## Concept Report Form

<b>Project Name</b>	Bridge over Branch									
<b>PIN</b>	134884.00									
<b>Route Information</b>	<b>Route</b>	<b>NHS (Y/N)</b>	<b>Functional Class</b>			<b>City</b>		<b>County</b>		
	SR-54	No	Rural Major Collector			Brownsville		Haywood		
<b>Project Information</b>	<b>Begin Log Mile</b>	<b>End Log Mile</b>	<b>AADT<sup>1</sup></b>	<b>Design Hour Vol. (DHV)<sup>1</sup></b>	<b>Truck %<sup>1</sup></b>	<b>Design Speed (MPH)</b>	<b>Posted Speed (MPH)</b>	<b>Base Year</b>	<b>Design Year</b>

**SR-54 BRIDGE [38SR0540005]  
BRIDGE OVER BRANCH  
L.M. 16.73**

**Comment Resolution: 134884.00, Haywood, SR 54, Bridge over Branch (TMA)**

FIGURE 1a  
S.R. 54  
L.M. 16.73

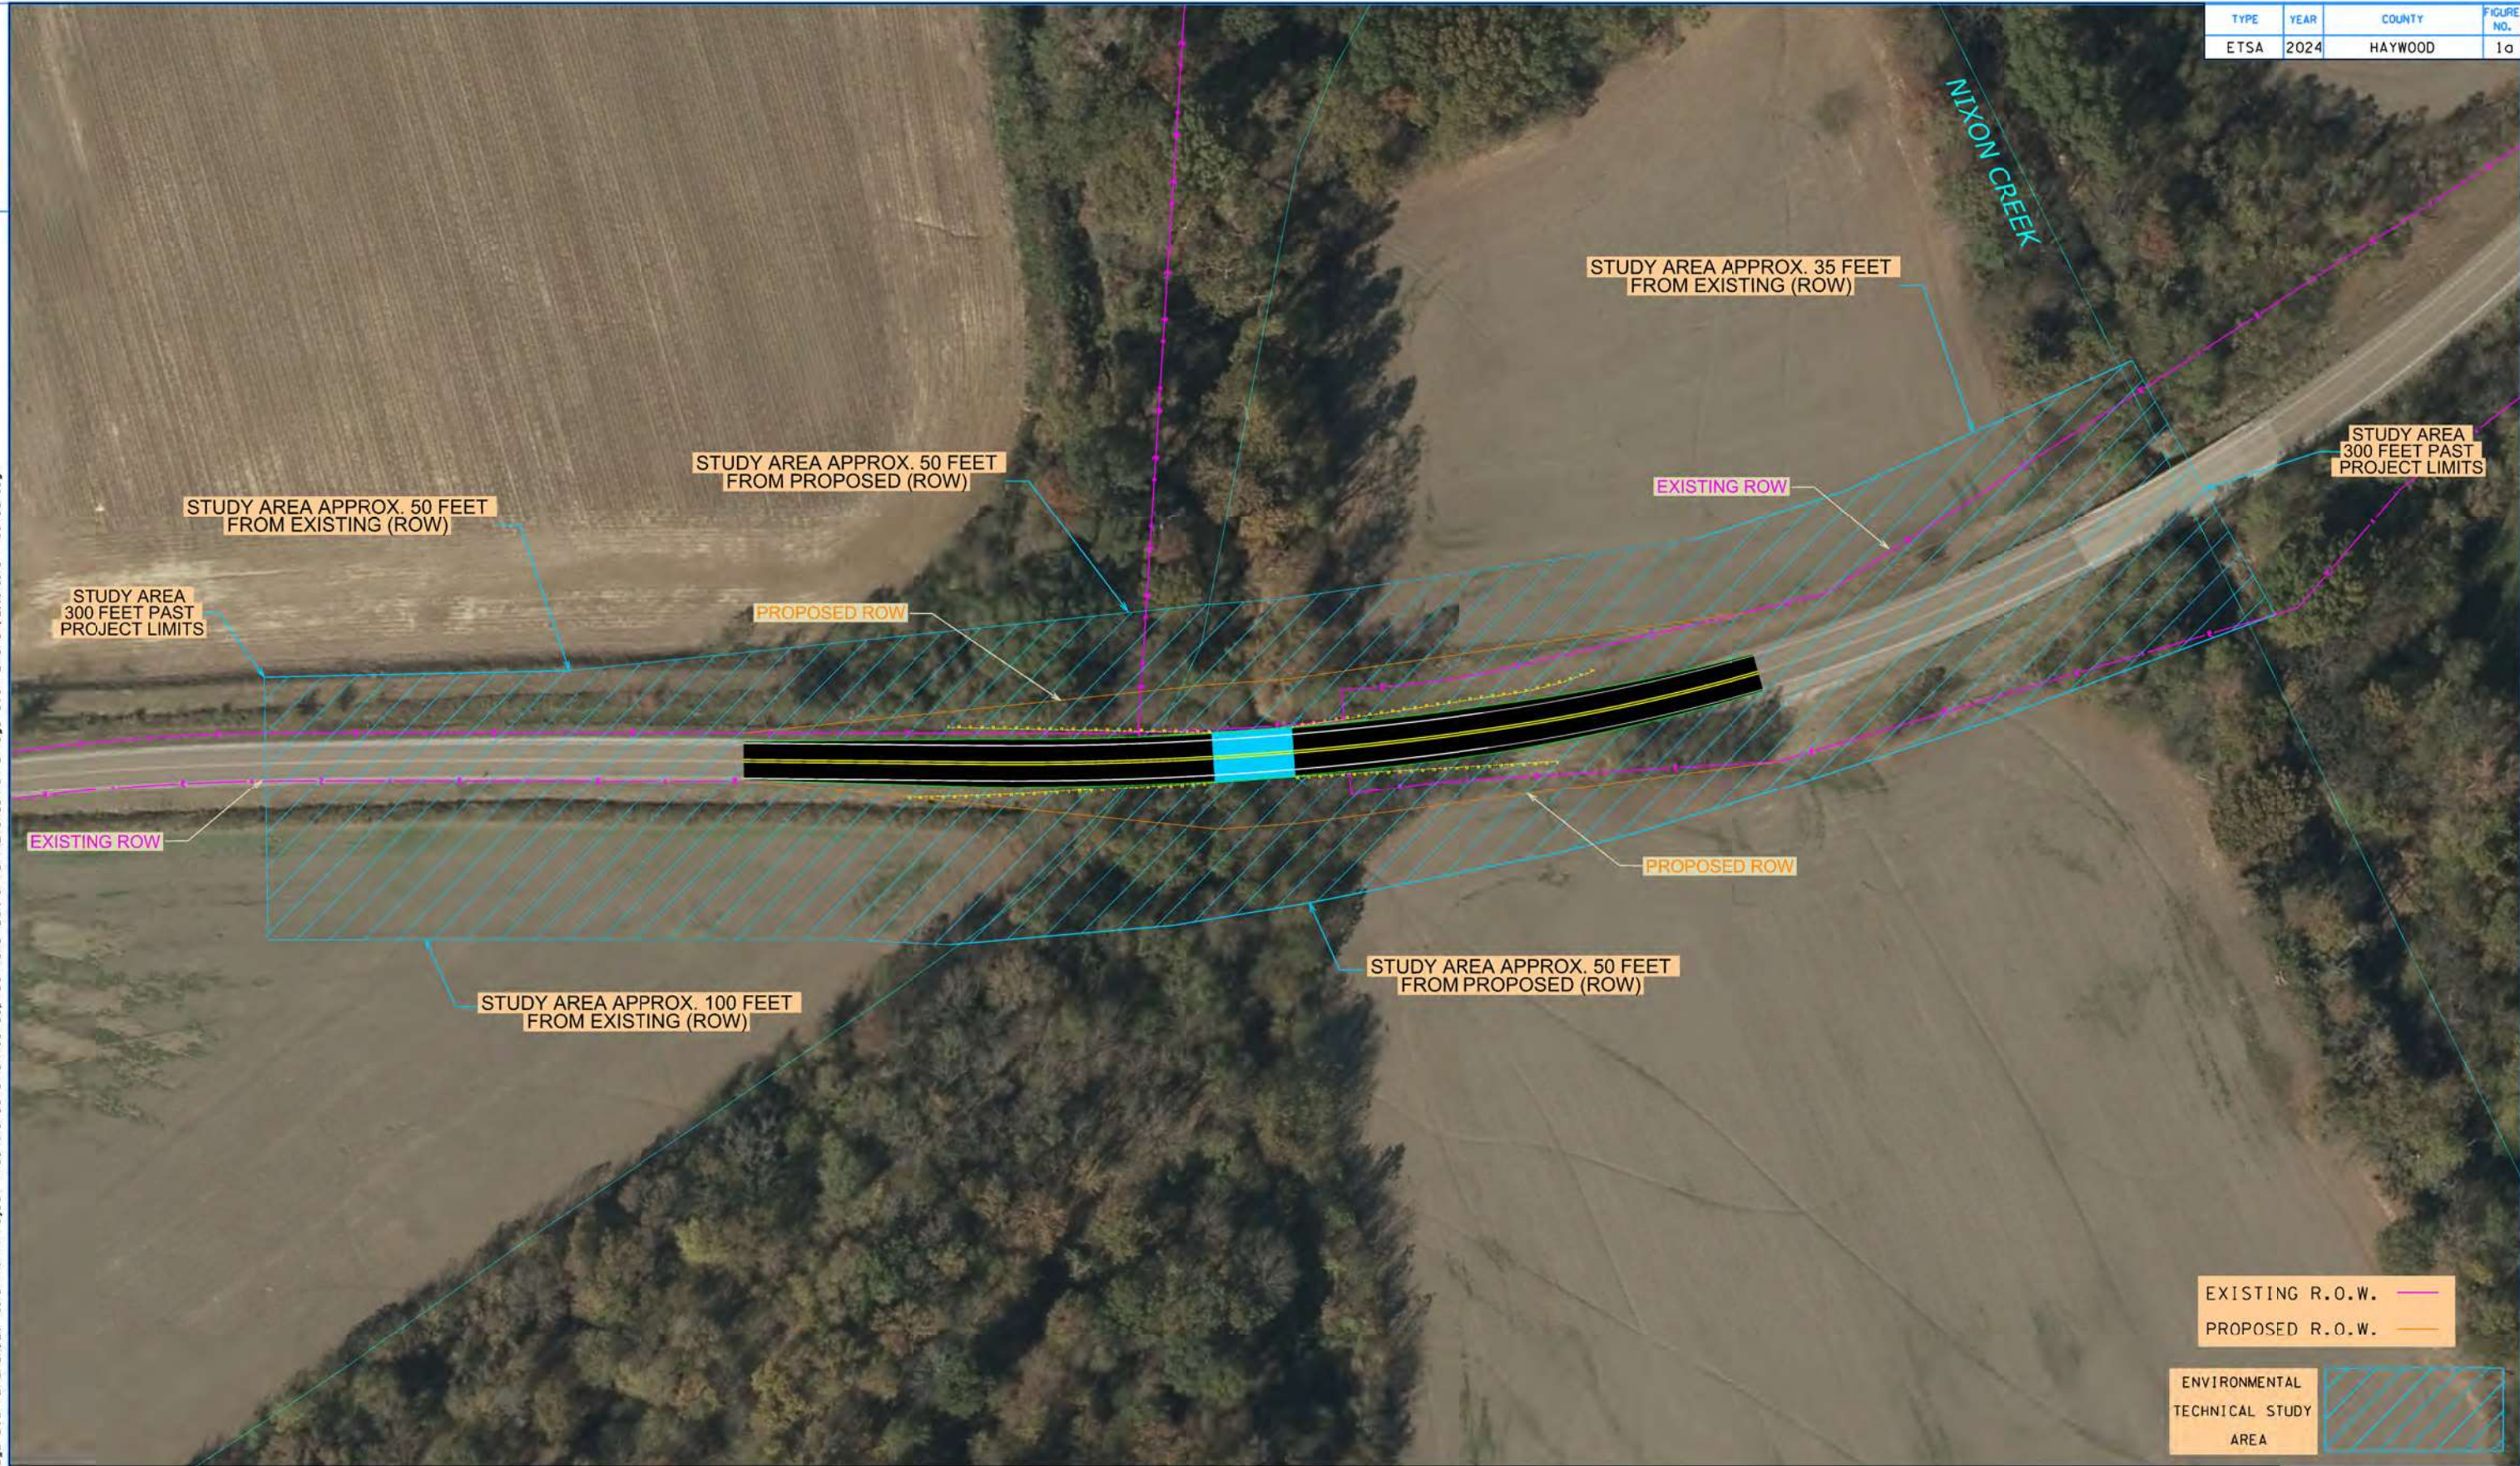
Consider combining the ETSA boundaries from Figure 1 a and Figure 2a. A single ETSA should be reasonably conservative to minimize the risk of a Reevaluation.
